Viktor Anderson  
Director of Engineering  
Structural Concepts Corporation

October 30, 2015

Subject: **Draft Strategy Reducing Short-Lived Climate Pollutants in California**

Chart A

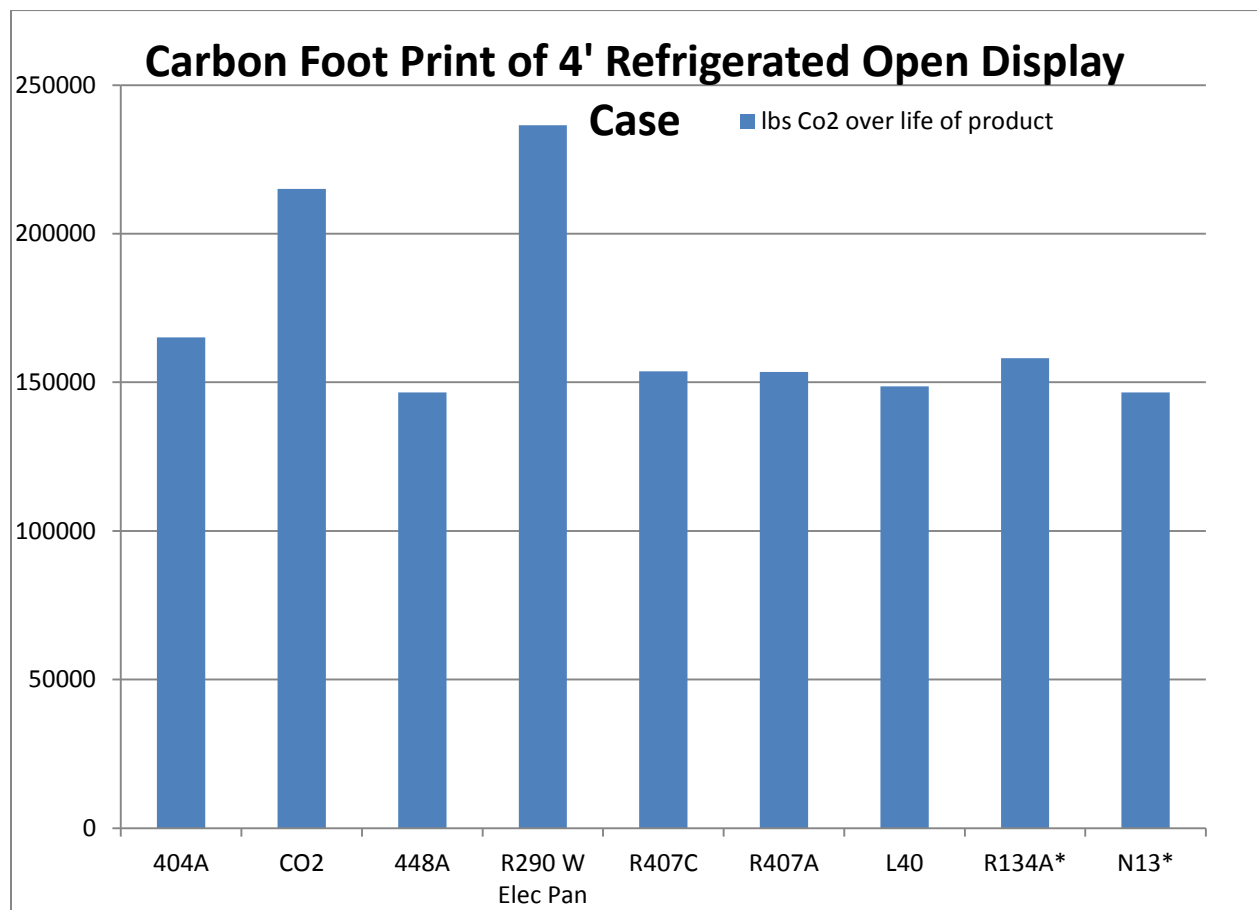
With the additional compressor required for 85% of our products, energy efficiency would be compromised given the typical low EER ratings on smaller compressors. This in turn would cause DOE energy levels to be exceeded unless the standards are re-evaluated given new circumstances. To keep the charge limit down, hot gas condensate heaters would need to be replaced with electric heaters again increasing overall energy consumption that could potentially put the unit over the allowable DOE energy levels but definitely raise the energy consumption. So for a 10 year life expectancy, all of our HC product would result in increased energy consumption and an increased overall carbon footprint between 10 and 40% over R404A. *Chart A refers to actual data collected and calculated per EPA web site.*

\* R134A and N13 configurations had to go to a larger compressor with an EER of 9.8 vs 7.7 of the R404a compressor due to the volumetric inefficiency of R134a vs R404a.
